Addendum 2

MONROE ROOF & GUTTER REPLACEMENT ITB

ITB NO. 2020.09.29

3 NEW ROOFING @ EXIST. SIDE WALL
SCALE: 1 1/2" = 1'-0"

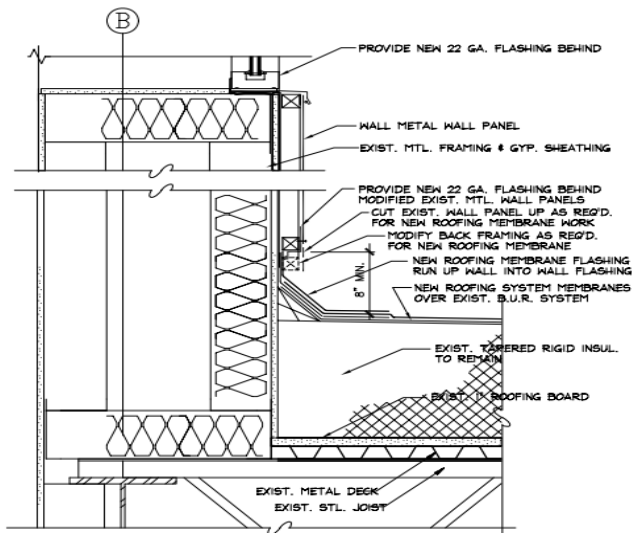
- The bid deadline was wrong in the Addendum 1 email sent out 10/13/20. **Bids are due by 5:00pm (Pacific local time), Tuesday, October 20, 2020.**
- **Q:** On detail 3 on A-3 concerning window flashing: Are all windows to be removed to install new 22 gauge flashing? If so, we will need to coordinate another site visit to address windows.
A: We do not need to remove the windows as they are set up high enough. We are only asking for the new 22 gauge flashing where the modification of existing wall panels is happening to support the 8" minimum rise.
